Copley Township Architectural Review Board

Monday, January 5, 2026

COPLEY TOWNSHIP SITE PLAN REVIEW MAJOR SITE PLAN/VARIANCE 1660 COLLIER ROAD STAFF REPORT

COPLEY TOWNSHIP SITE PLAN REVIEW MAJOR SITE PLAN/VARIANCE 1330 S CLEVELAND MASSILLON RD STAFF REPORT

ELEVATIONS

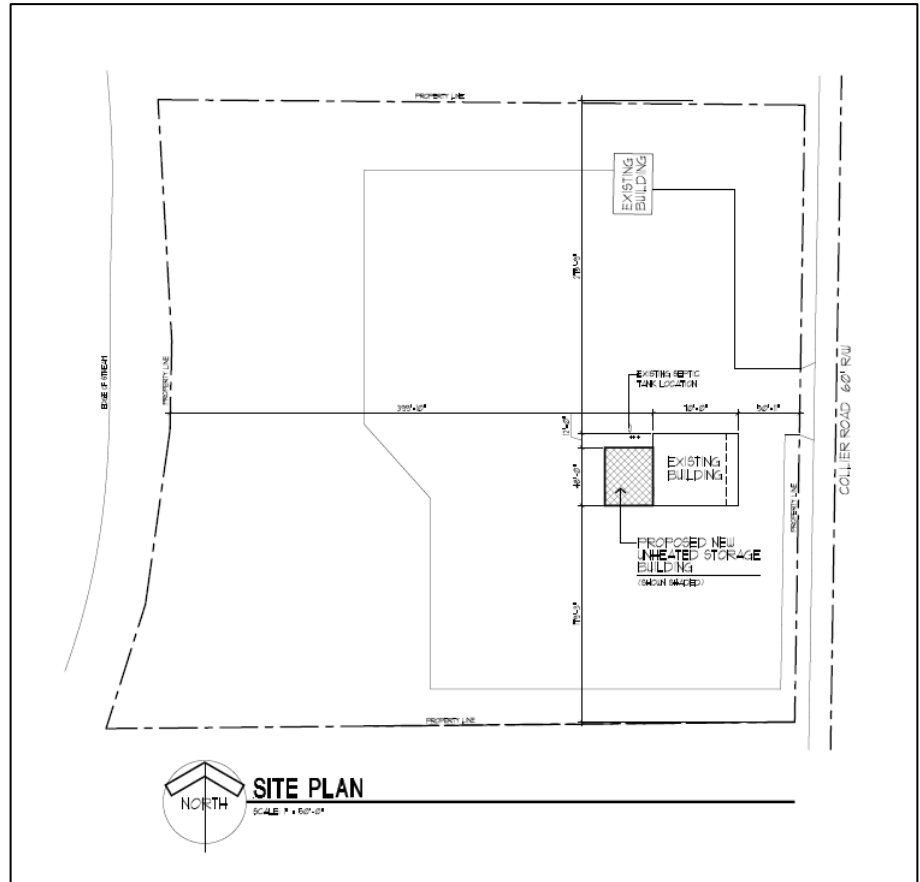
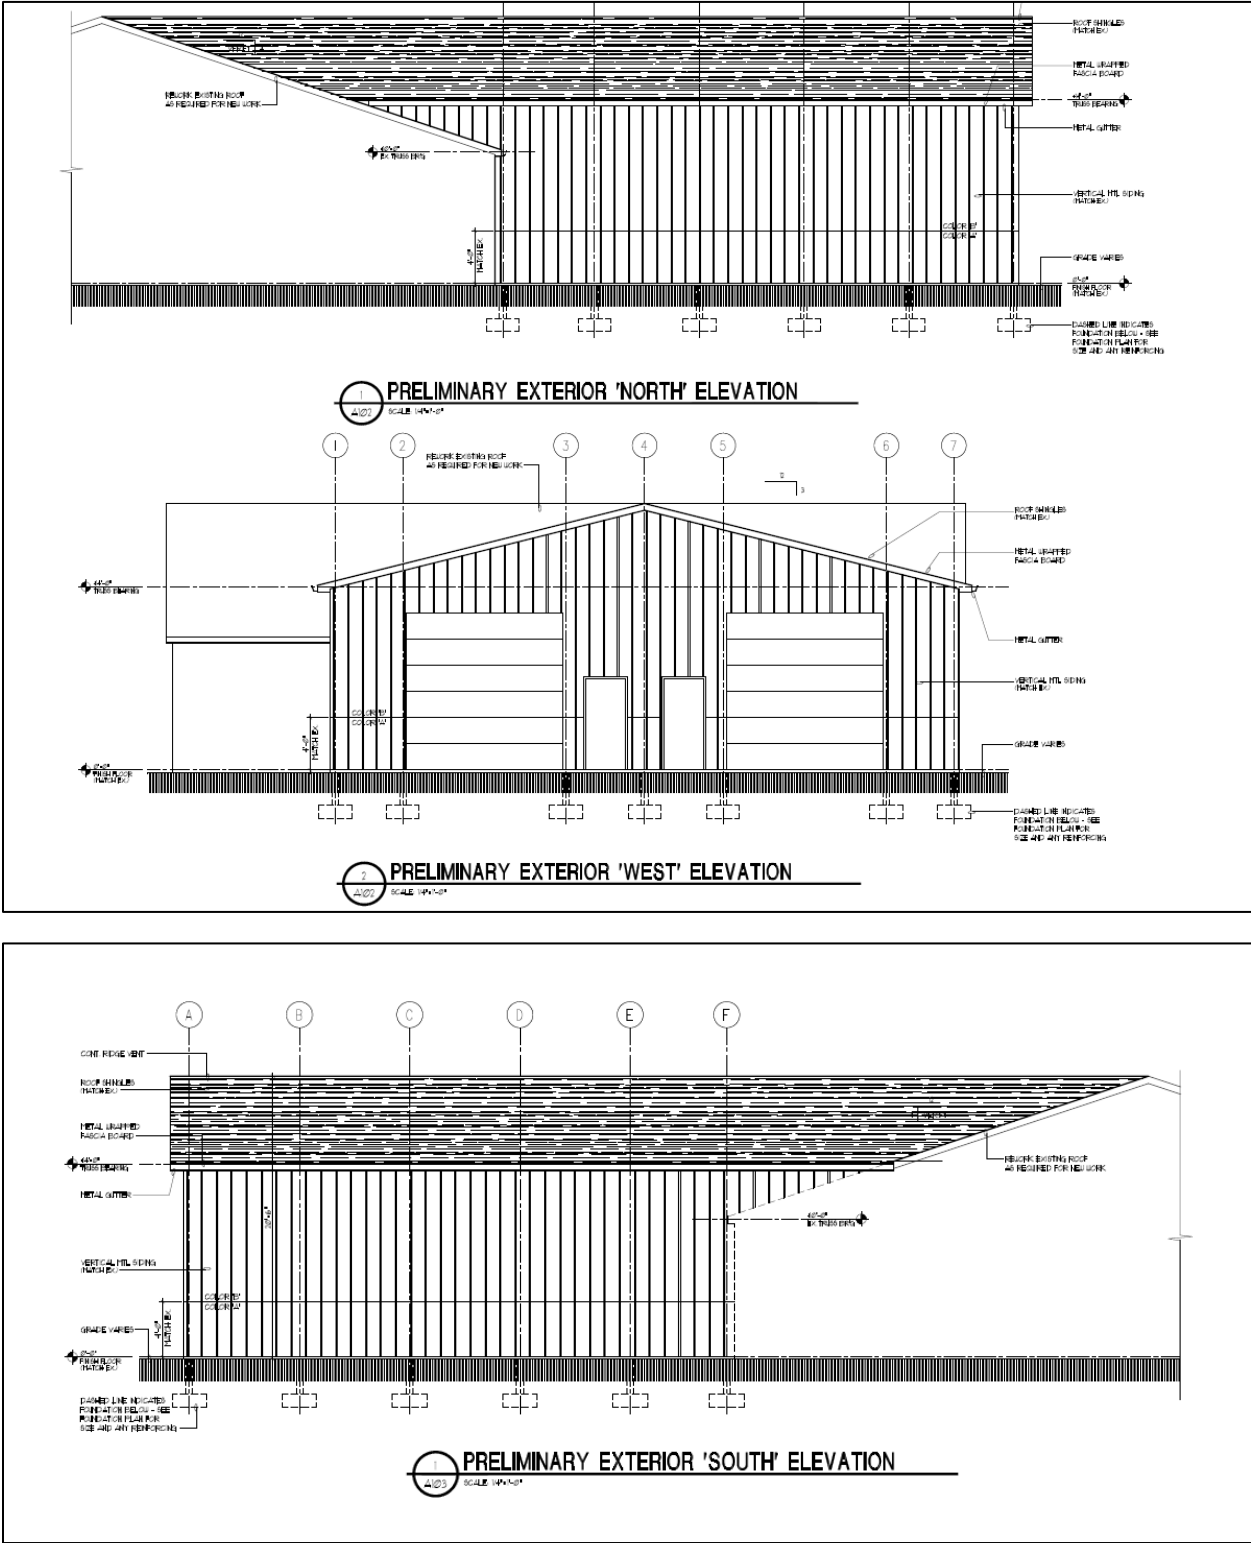
Applicant, Jared Kiehl, on behalf of Kiehl Construction is requesting site plan and variance approval to construct a commercial building addition within an identified floodplain.

The addition is 1920 square feet in overall area (40' x 48'). The addition will be utilized as cold storage.

Copley Township Architectural Review Board	Recommend approval of site plan conditioned upon jurisdictional approval and receipt of necessary variance
Copley Township Fire Department	No objection
Copley Township Service Department	No objection
Copley Township Police	No objection
Summit County Engineers Office	No stormwater detention will be required for this addition. A grading permit will be required. The site plan will need to identify roof drain/downspout tie-in locations.
Summit County Floodplain Administration	Pending review

On January 5, 2026, the **Copley Township Architectural Review Board** motioned to recommend approval of the applicants Major Site Plan Application inclusive of a 1920 square foot addition and request for the variance required for construction within the identified floodplain

Staff Comment: Conditioned upon agency review and approval

ELEVATIONS

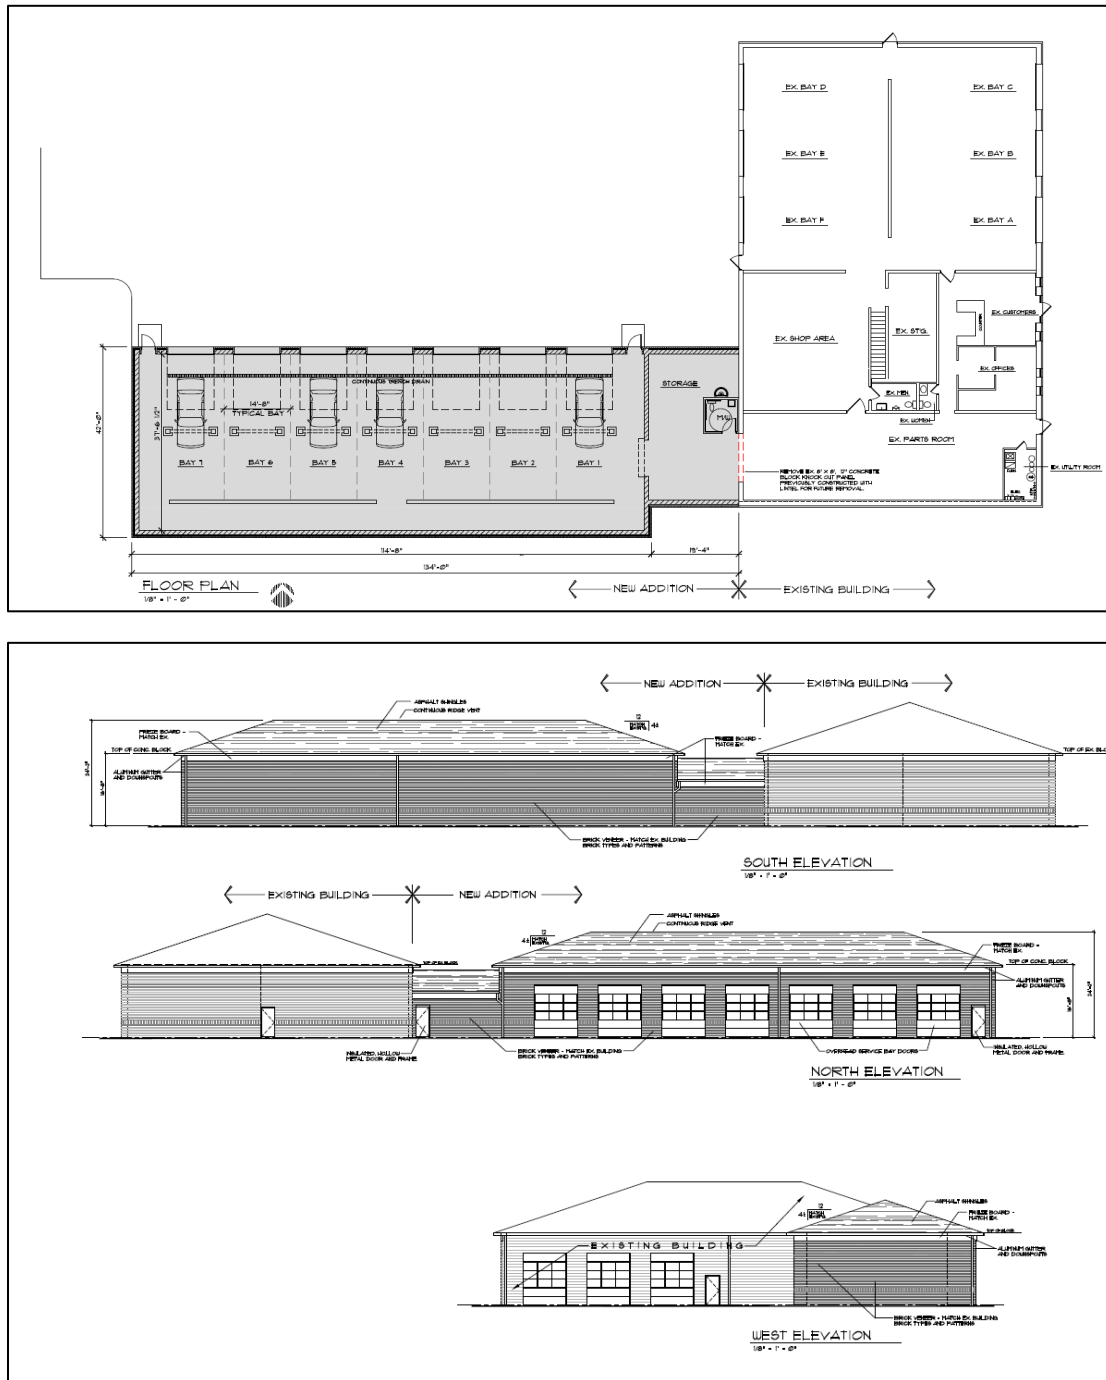
The applicant plans to reconfigure the existing parking lot which will result in a reduction of 9 parking spaces and an increase of 1,600 square feet of new impervious surface for the proposed lot along the western side yard property line.

Section 14.06-Building Façade Landscaping the applicant is required to provide landscape at least 75% of the building façade to include at minimum of 3 trees for every 100 lineal feet. At 60' of building frontage, the applicant is required to install 2 trees.

ARB APPROVED: Accept Sunset Drive plantings to satisfy requirement for building façade landscaping

1. *Reduction in the parking landscape buffer along with western property line from 10' to 6' and waiver of buffer for previously installed parking spaces in 2024.*
2. *Accept Sunset Drive plantings to satisfy requirement for building façade landscaping*
3. *Waive landscape island requirement for previously installed parking spaces in 2024*

1. Section 9.06 5. Variance to encroach 1' into the required 25' front yard setback along Sunset Drive
2. Section 9.06 B. a. Variance to maintain gravel surface for parking area along the western property line
3. Section 9.06 9. Relief from requirement to utilize wheel stops for parking area along western property line

ARTICLE 4., SECTION 4.01

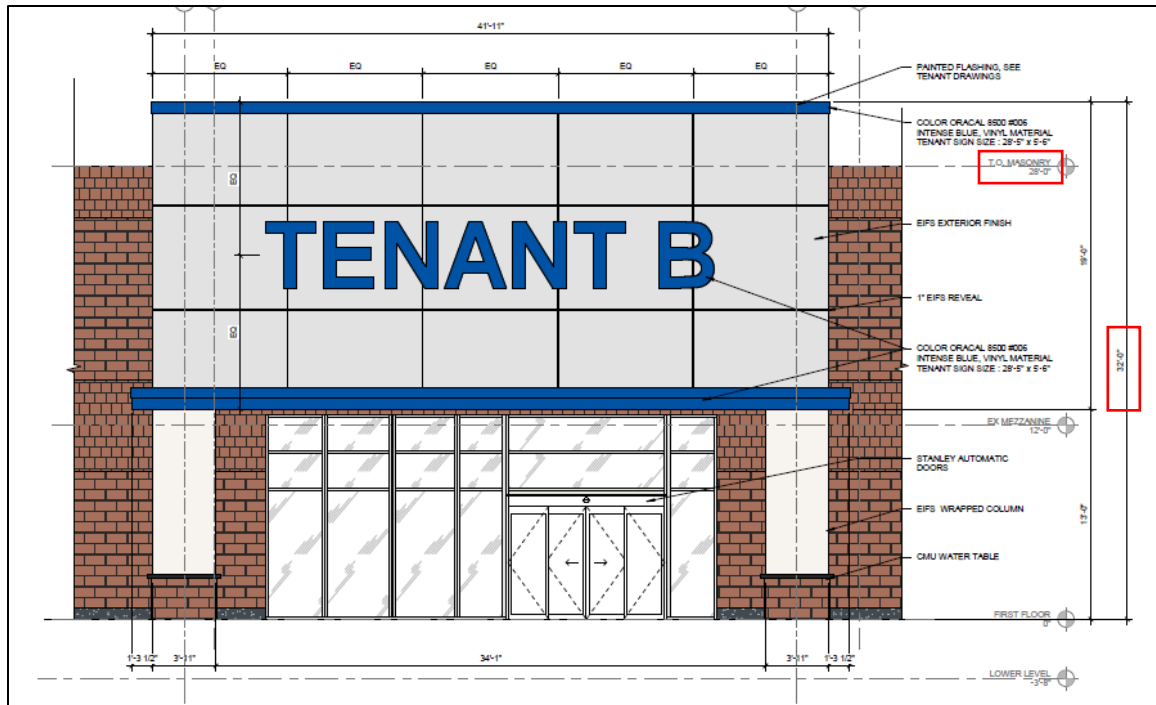
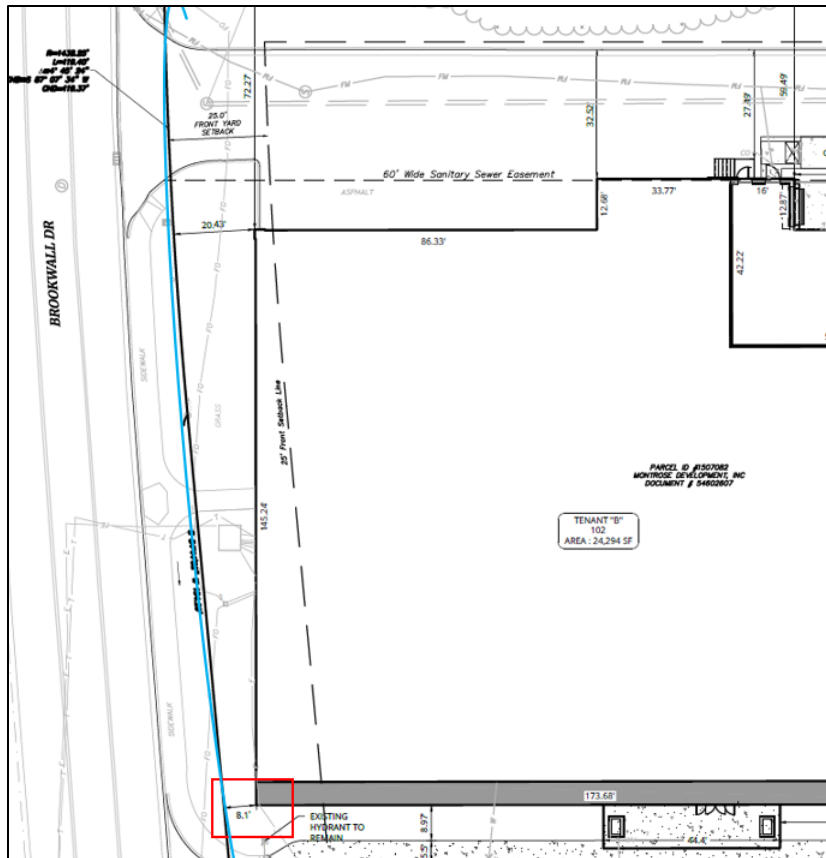
- 35' Maximum Building Height
 - Masonry Height: 28'
 - Parapet Wall: 32' for Tenant A & Tenant B

- 50' Minimum Rear Yard Setback (SOUTH)
 - o 750' +
- 25' Minimum Side Yard Setback
 - WEST: 59'
 - EAST: 400' +
- 25' Minimum Front Yard Setback (NORTH)
 - o 8.1' Non-conforming

Variance Rationale: The front yard setback is pre-existing and created due to the expanded right of way for the installation of Brookwall Drive. This variance will correct the non-conforming setback.
